ALASKA LNG

**DOCKET NO. CP17-____-000
RESOURCE REPORT NO. 10
ALTERNATIVES
PUBLIC**

DOCUMENT NUMBER: USAI-PE-SRREG-00-000010-000

Resource Report No. 10 Agency Comments and Requests for Information Concerning Alternatives			
Agency	Comment Date	Comment	Response/Resource Report Location
BLM	9/26/2016	When the requirement for ultra-low sulfur diesel came into effect there was a decision made not to put a desulfuring plant on the north slope. As a result, truck traffic hauling diesel up the Dalton Highway increased considerably, and truck rollovers with fuel spills went from one every couple of years to 7 or 8 in one year. Given the amount of diesel required for this project, the applicant may want to consider including a desulfuring plant on the north slope. If not, then the EIS needs to include a thorough analysis of the risks of fuel spills, associated costs, and potential mitigations associated with the expected increase in trucking of fuel on the Parks and Dalton Highways.	Comment acknowledged.
BLM	9/26/2016	Relocating this proposed compressor station to an area using natural topographic land breaks between the compressor station and Galbraith Lake could reduce or alleviate thes

FIGURE 10.5.7-2

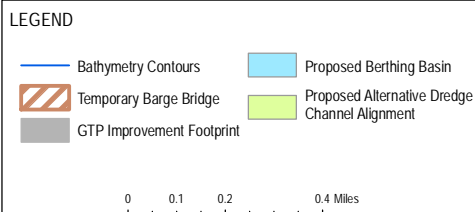
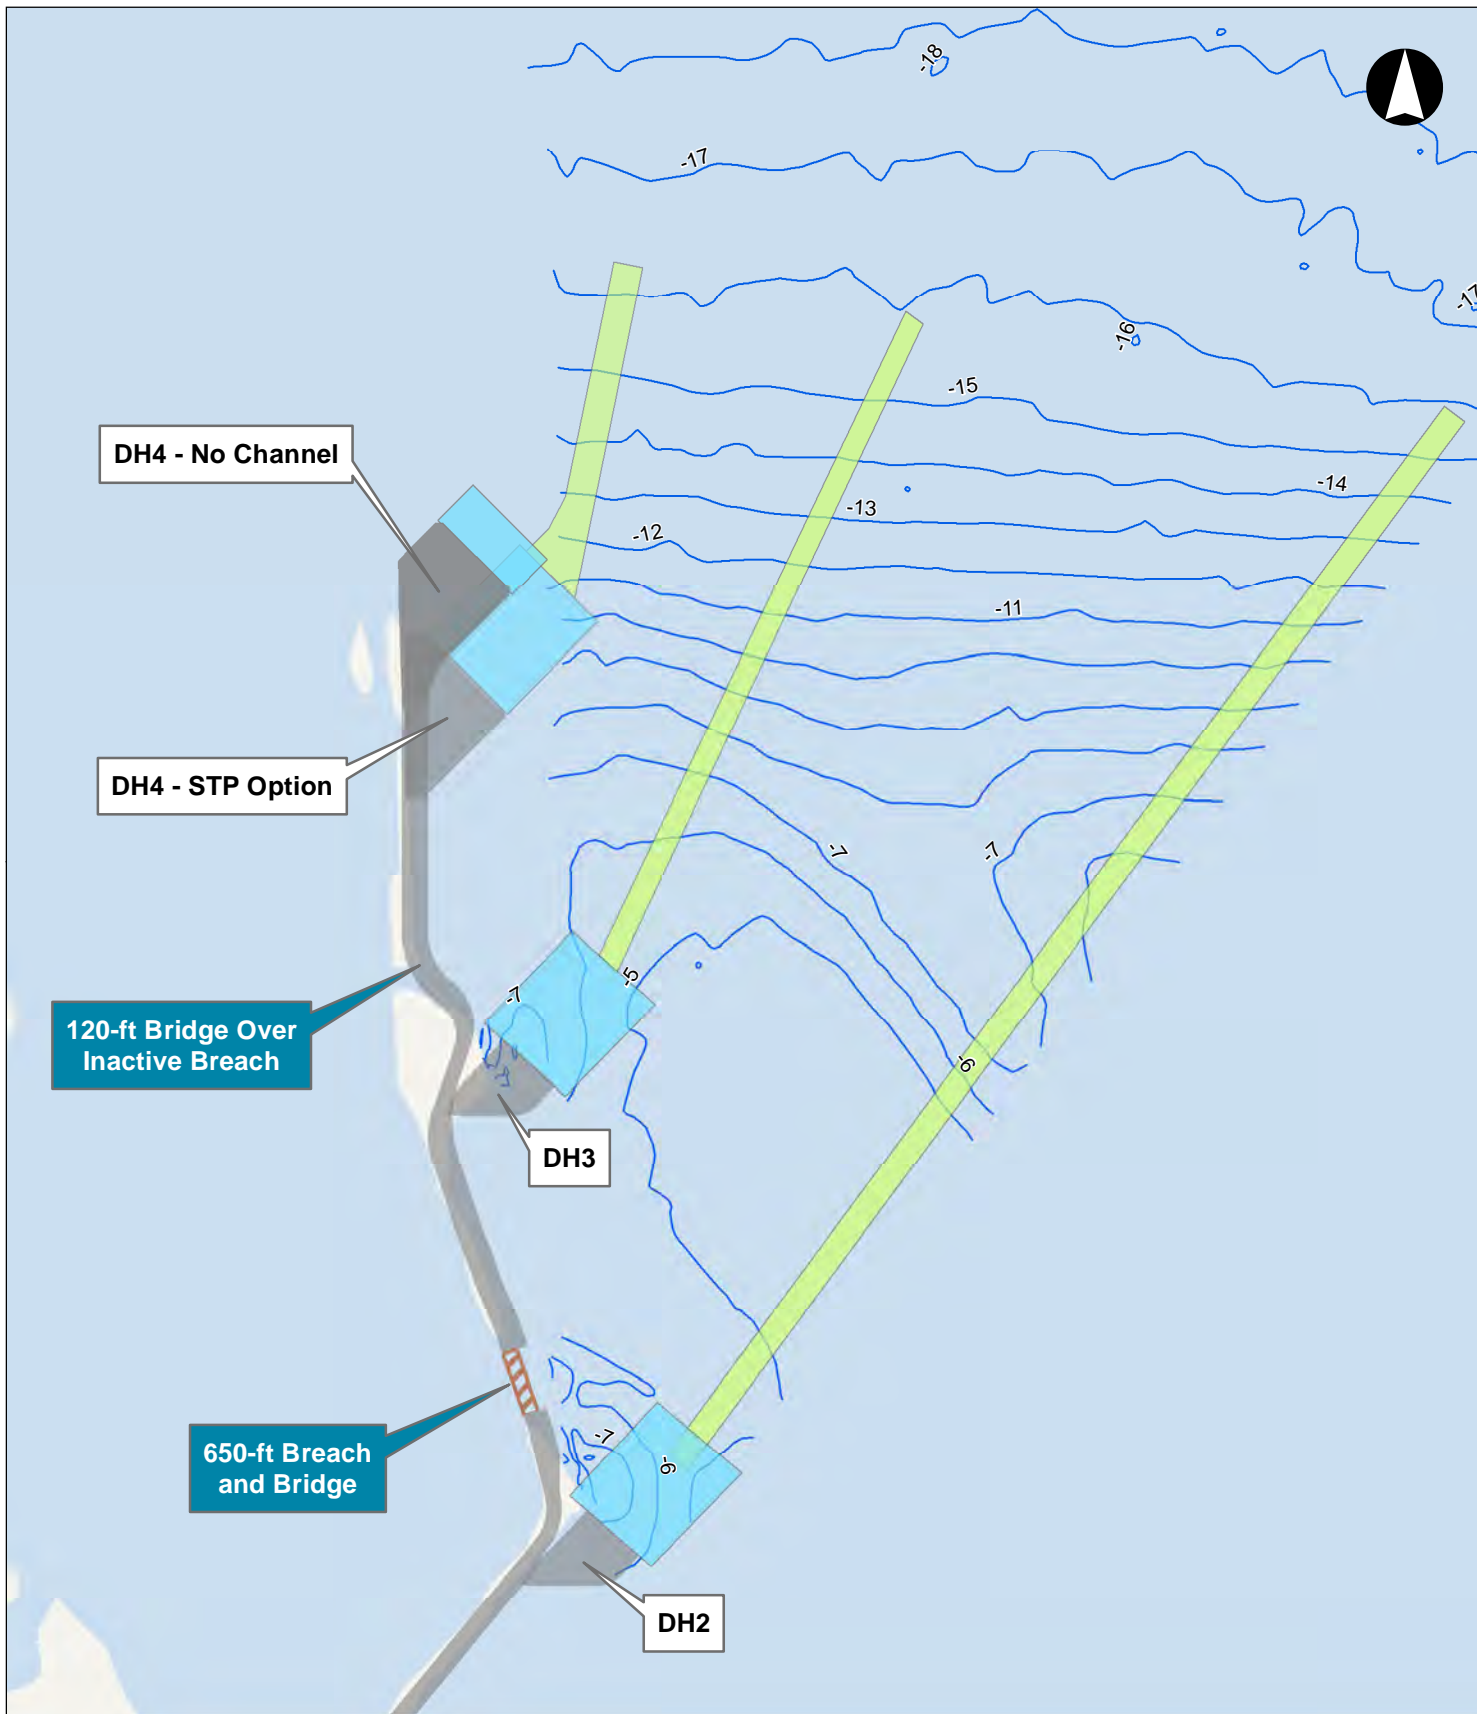
FERC	10/26/2016	25. Include a figure showing the proposed and alternative configurations for Dock Head 4.	See Figure 10.5.7-2.
FERC	10/26/2016	26. Include a comparative estimate of air pollutant emissions from the Dynamically Positioned (DP) Lay Vessel with Anchor Moorings (Applicants' Proposed Alternative), and the Conventionally Moored Lay Vessel Alternative.	The Applicant will address this comment prior to the initiation of the EIS process.
FERC	10/26/2016	27. Include a comparative estimate of noise levels (i.e. intensities and durations) from the DP Lay Vessel with Anchor Moorings (Applicants' Proposed Alternative), and the Conventionally Moored Lay Vessel Alternative.	The Applicant will address this comment prior to the initiation of the EIS process.
FERC	10/26/2016	28. Include the basis for the statement that the preferred DP lay barge method may require an incidental harassment authorization from NMFS, while a conventional mooring system probably would not; include any correspondence with the NMFS regarding the matter.	The Applicant will address this comment prior to the initiation of the EIS process.
